ON-SITE SEWAGE DISPOSAL SYSTEM
HOWARD COUNTY HEALTH DEPARTMENT
BUREAU OF ENVIRONMENTAL HEALTH

05-349303

ADDRESS: 11722 Wayneridge Street

SITE INSPECTION SHEETOWNER: Kenneth EllisPHONE #: 301-725-6190ADDRESS: 11722 Wayneridge StCONTRACTOR: EasterdayTulton 20759

SUBDIVISION: Mooresfield LOT: 3 BLC S 2 COUNTY #: _____PROPOSAL: Dirty WaterLOCATION DIAGRAM

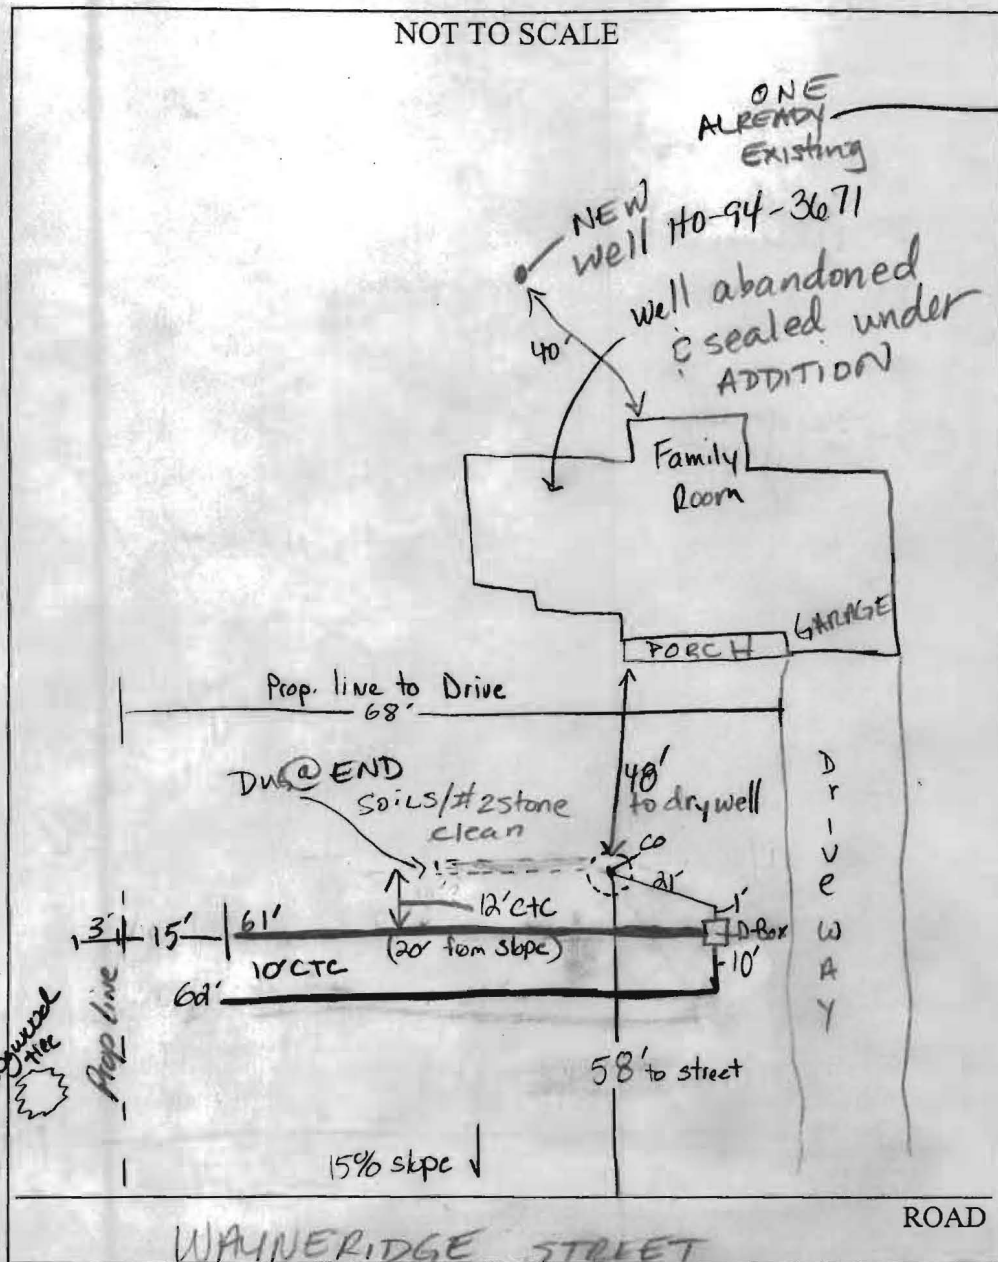
COMMENTS: 3/24/03 EXISTING WELL TO BE ABANDONED PER DISCUSSIONS w/
OWNER & G. EASTERDAY; ANY ADDITION OF BEDROOM WOULD REQUIRE UPGRADE OF
EXISTING SEPTIC SYSTEM. KN/FA

PRE-CONSTRUCTION 1/13/04 Upgrade: Soils consistent throughout area. Current 38' trench still functioning & dry well effluent below inlet.

INSTALLATION Conserve as much area as possible. The two new trenches & d. box inlet a few inches lower & use existing trench as overflow = trenches fail at same time. Contractor to call in follow-up. SEE PERC SHEET FOR SOIL PROFILE. 1/14/04 Inlet at d. well 16" below lid; app. 4" lower than inlet for existing 38' trench, ok to cover work completed (EN/KR)
